SITE PLAN
FOR
VINCE TASSONE
BEING S/L 36 IN THE BIG CREEK SUBD. IN THE
TOWNSHIP OF CONCORD, LAKE COUNTY, OHIO

VILLAGE SURVEYING CO.
FAIRPORT HARBOR, OHIO 44017
(216) 357-1359

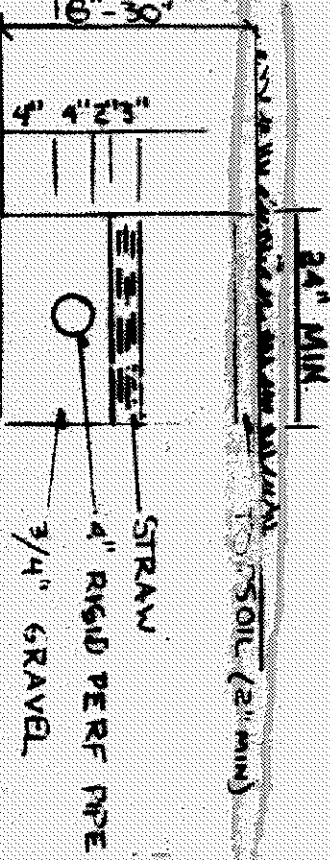
SEWER LAYOUT, PRELIMINARY, BEING REVIEWED BY A LAKE COUNTY LICENSED ENGINEER BEFORE INSTALLATION IS

LOW YIELD WATER
FIXTURES REQUIRED
ON ALL
Summer Head
Tank

- A. To be brought to finished grade
- 1. Septic tank manhole cover
- 2. Splitter box cover
- 3. Distribution box cover
- B. No foot or draft for downspouts to be discharged into septic tank
- C. All waste water to be discharged into septic tanks

* Grinder Pump
Rego in Pumping
in Basement

Reviewed and Accepted
LAKE COUNTY GENERAL HEALTH DISTRICT
4-13-94
JES. LIPKA, E.S., M.P.E.
Health Commissioner

Grading Plan Approved
as shown and/or noted
THOMAS P. GILLES, P.E.
Lake County Engineer
